Orchard View: Preliminary Plan No. 120160120

Staff Report Date: 3/24/17

Staff Recommendation: Approval with Conditions

Figure 3 – Preliminary Plan

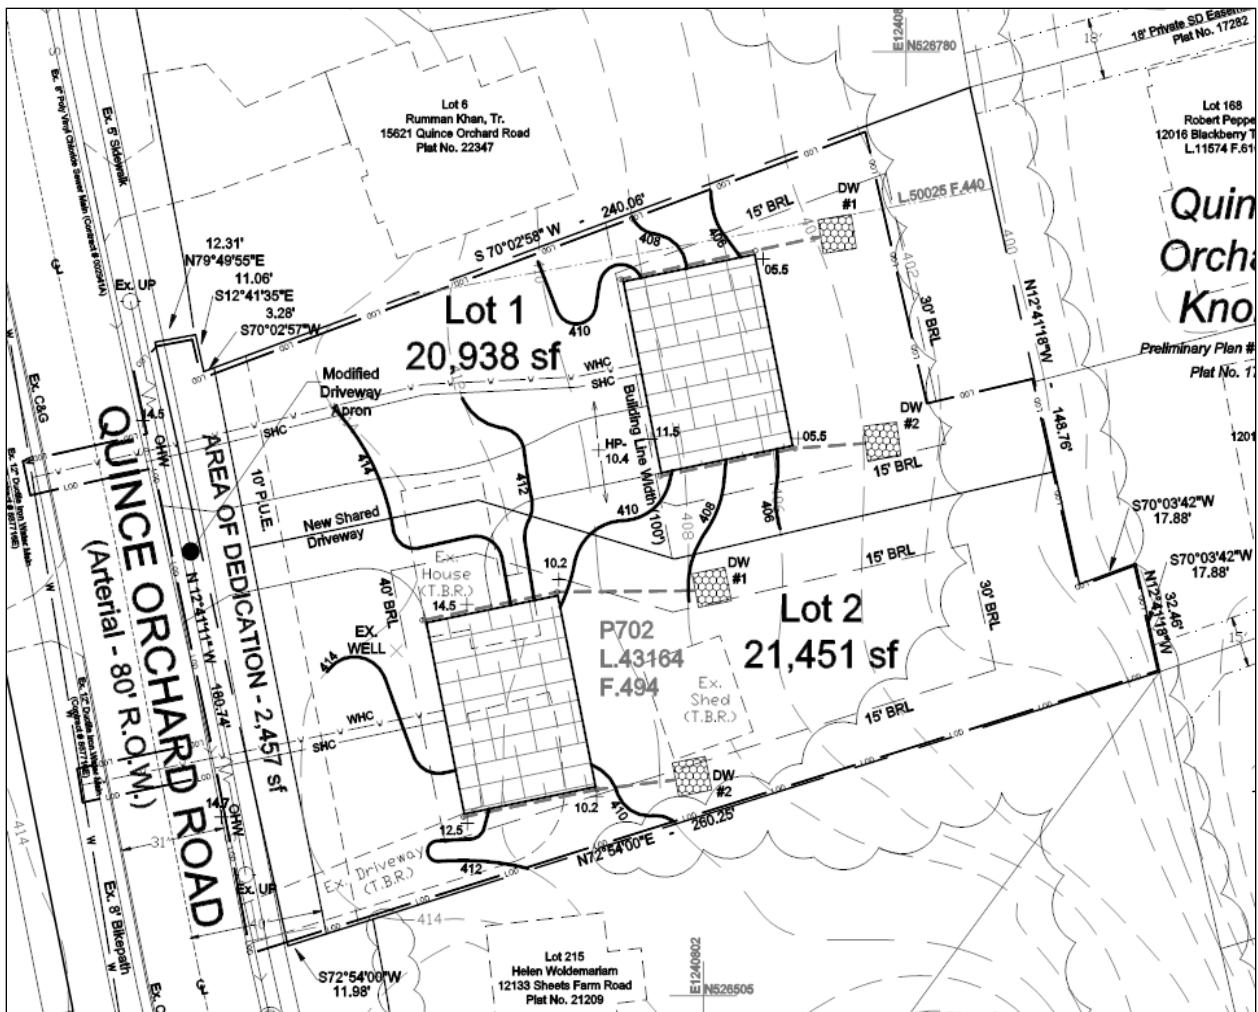
We have completed our review of the revised preliminary plan dated January 11, 2017. A previous plan was reviewed by the Development Review Committee at its meeting on January 25, 2016. We recommend approval of the plan subject to the following comments:

1. Necessary dedication for future widening of Quince Orchard Road in accordance with the master plan.
2. Grant necessary slope and drainage easements. Slope easements are to be determined by study or set at the building restriction line.
3. The storm drain analysis was reviewed and is acceptable to MCDOT. No improvements are needed to the downstream public storm drain system for this plan.
4. The sight distance study has been accepted. A copy of the accepted Sight Distance Evaluation certification form is enclosed for your information and reference.

5. Provide a ten (10) foot wide Public Utility Easement (PUE) along the existing street frontage.
6. Record Plat to reflect an easement for the private shared driveway.

7. Private common driveways and private streets shall be determined through the subdivision process as part of the Planning Board's approval of a preliminary plan. The composition, typical section, horizontal alignment, profile, and drainage characteristics of private common driveways and private streets, beyond the public right-of-way, shall be approved by the Planning Board during their review of the preliminary plan.

Figure 4 - Location of specimen trees

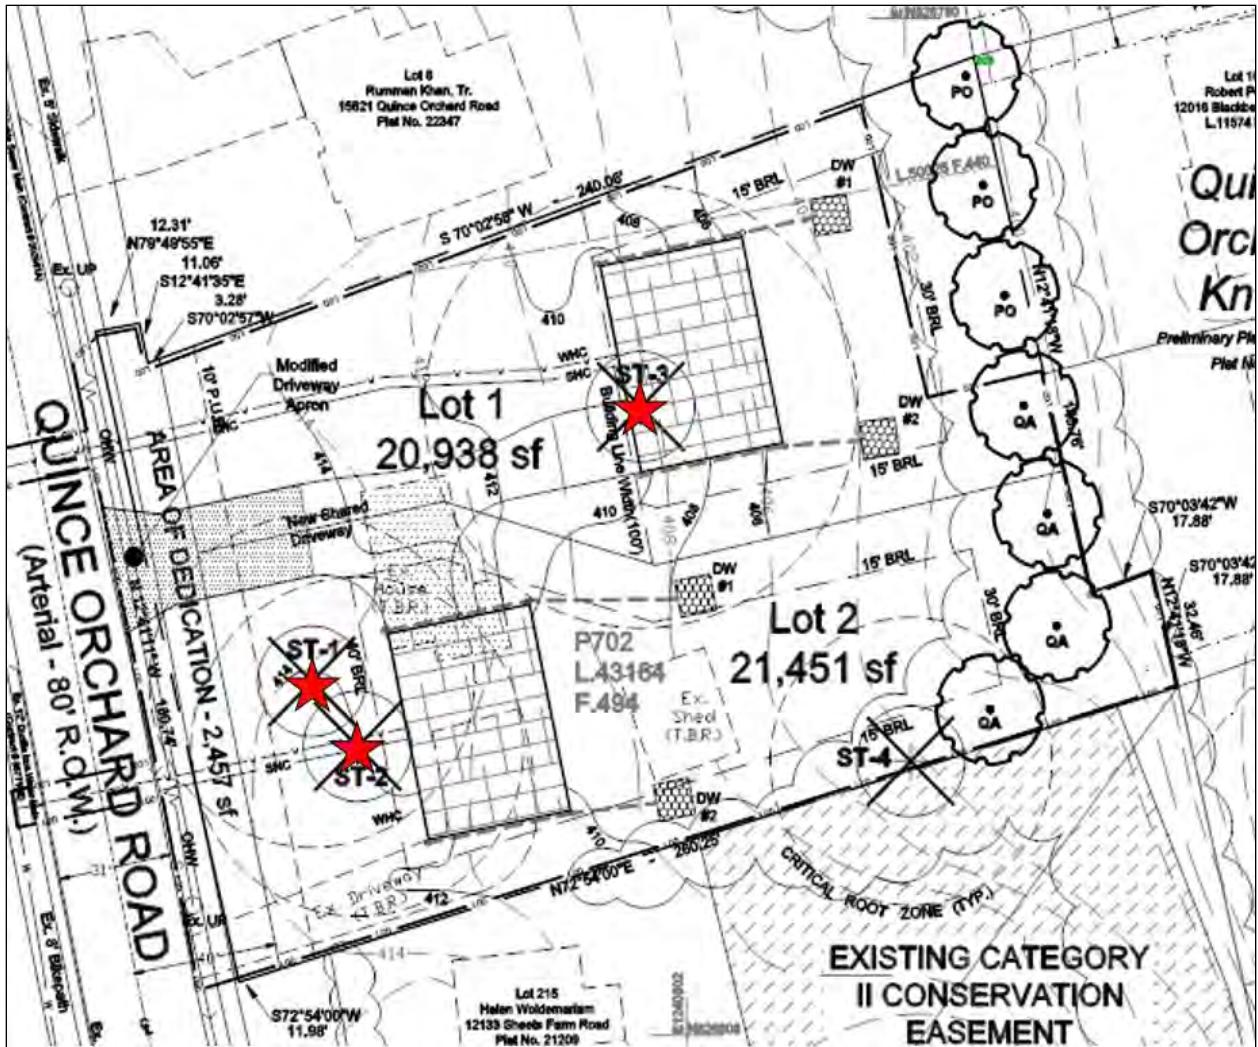
Variance Request - The Applicant submitted a variance request in a letter dated October 16, 2015 (Attachment D). The Property contains three specimen sized trees that are 30 inches or greater DBH, that are considered high priority for retention under Section 22A-12(b)(3) of the County code (Table 1). The Applicant requests a variance from the Forest Conservation Law due to proposed the impacts and proposed removal of these three trees.

The Application consists of two parcels totaling 1.03 acres in the R-200 zone being subdivided into two lots of approximately 20,000 square feet each. Due the required minimum lot size of 20,000 square feet in this zone and the necessary building restriction lines, flexibility on the placement of the residential structures is greatly limited and impacts to these three specimen trees is unavoidable. Not being able to obtain a variance from Section 22A-12(b)(3) would constitute an unwarranted hardship on the Applicant by not being able to develop the Property allowed by the zoning ordinance. Therefore, Staff concurs that the Applicant has a sufficient unwarranted hardship to justify a variance request.

The arboriculture industry standard for construction impacts to trees is to limit those impacts to no more than approximately 30 percent of the Critical Root Zone (CRZ). More than 30 percent impact to the CRZ and the overall healthy viability of the tree comes into question. Trees ST-1 and ST-2 are located adjacent to the proposed structure on Lot 2 and will have approximately 50 percent of their respective CRZs impacted with construction. Tree ST-3 is located within the building envelope of the house on Lot 1 and will have 100 percent impact to its CRZ. Given the amount of impacts to these trees and their current condition staff believes that removal is the best option since these trees, especially Trees ST-1 and ST-2, will become hazard trees in the future due to significant impact to the critical root zones.

Mitigation for Trees Subject to the Variance Provision - There are three trees proposed for removal in this variance request which when added together results in a total of 101.6 inches of DBH being removed. For removal of specimen trees associated with a variance request, Staff recommends mitigation for the tree loss by replacing the total number of DBH removed with $\frac{1}{4}$ of the amount of inches replanted. This results in a total mitigation of 25.4 inches of replanted trees. The Applicant proposes to plant a total of 28" DBH of mitigation trees by installing seven 4" caliper overstory trees native to the Piedmont Region of Maryland on the Property. These trees are to be planted outside of any rights-of-way or utility easements and these trees are not to be counted as an element of the site screening requirements.
